For: **RESURF LDMOS INTEGRATED  
STRUCTURE**

PRELIMINARY AMENDMENT

SUBMISSION OF PROPOSED MODIFICATIONS TO DRAWINGS

Fig. 1a

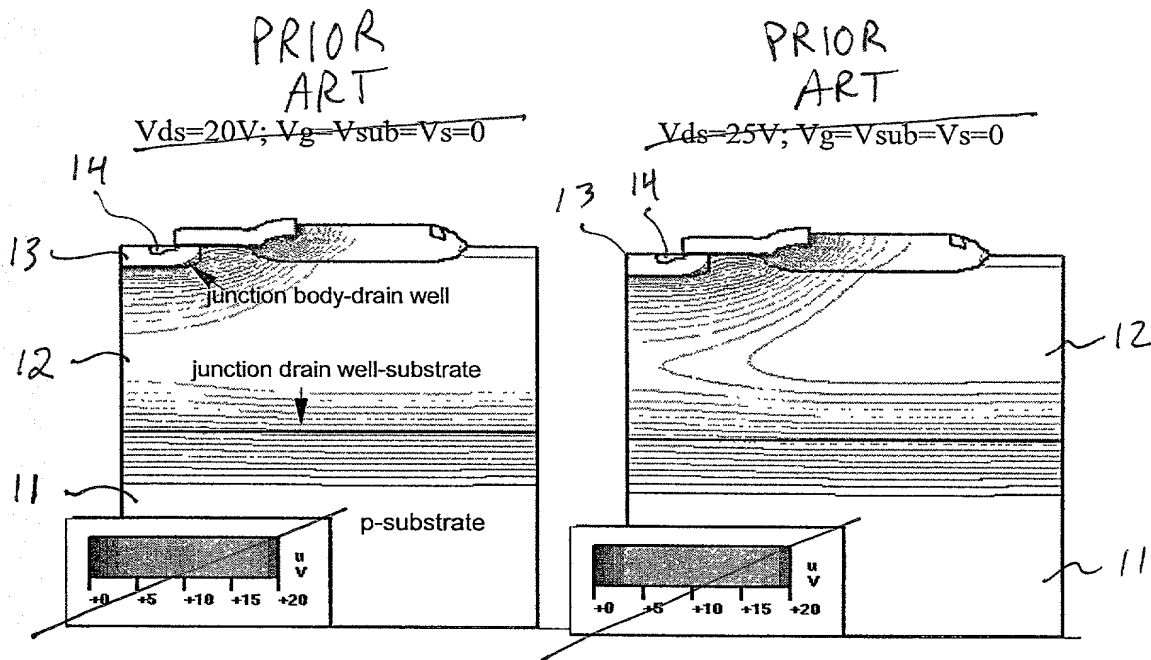
Submitted herewith is a request for a proposed drawing modification as indicated in red ink to re-label FIG. 2 as FIGS. 2a and 2b and to label FIGS. 1a, 1b, and 2a as prior art. Furthermore, reference numbers are being added to FIGS. 1a, 1b, 2a, 2b, 3a, and 3b in accordance with the specification for clarity. Certain text is also being deleted from FIGS. 1a, 1b, 3a, and 3b for clarity. No new matter is being added.

Fig. 2a

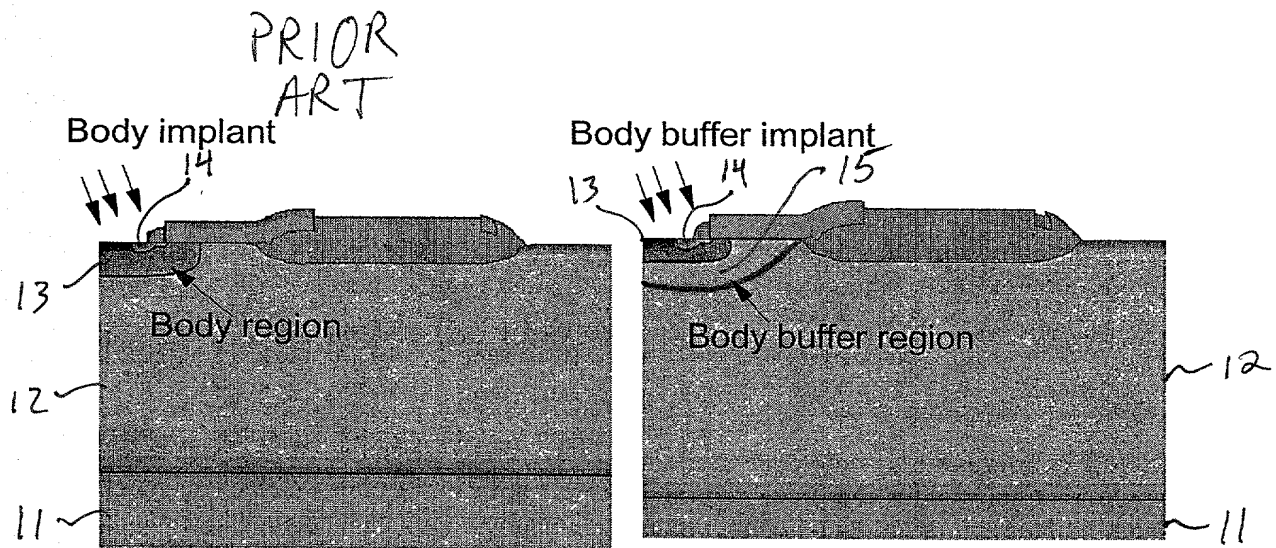
~~Fig. 2~~

FIG. 2a is a cross-sectional view illustrating a traditional LDMOS structure according to the prior art; [and a]

FIG. 2b is a cross-sectional view illustrating an LDMOS structure of the invention;
